Technical Service Bulletin

97 MIL on: DTC U064100 or U064000 for fuel tank breather - 2.0 ltr. TFSI EA888

97 24 05 2069123/2 January 18, 2024. Supersedes Technical Service Bulletin Group 97 number 23-90 dated January 17, 2023 for reasons listed below.

Model(s)	Year	VIN Range	Vehicle-Specific Equipment
A4, A4 allroad, A5, A5 Cabriolet, and A5 Sportback	2021 – 2023	All	Not Applicable

Figure 2: Wires isolated for modification.

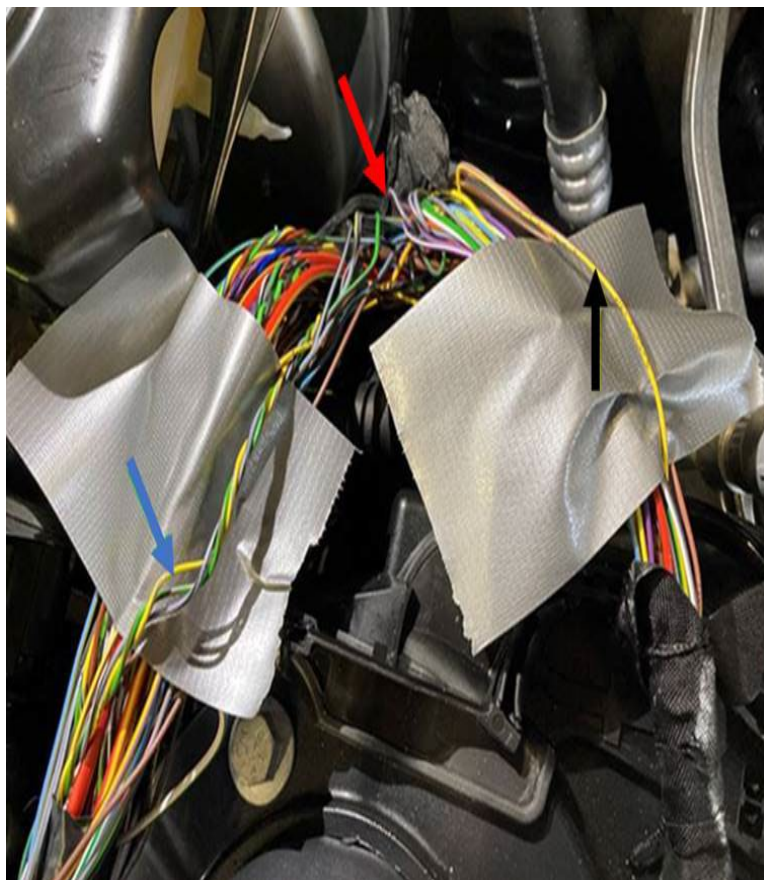
2. Isolate the yellow/grey wire (triple twisted wire; blue arrow, figure 2) in the left bundle.

Isolate the yellow/purple wire in the right bundle (black arrow, Figure 2).

Cut the yellow/grey wire at the blue arrow and unravel it in the direction of the plenum chamber up to the red arrow.

Cut the yellow/purple wire at the black arrow.
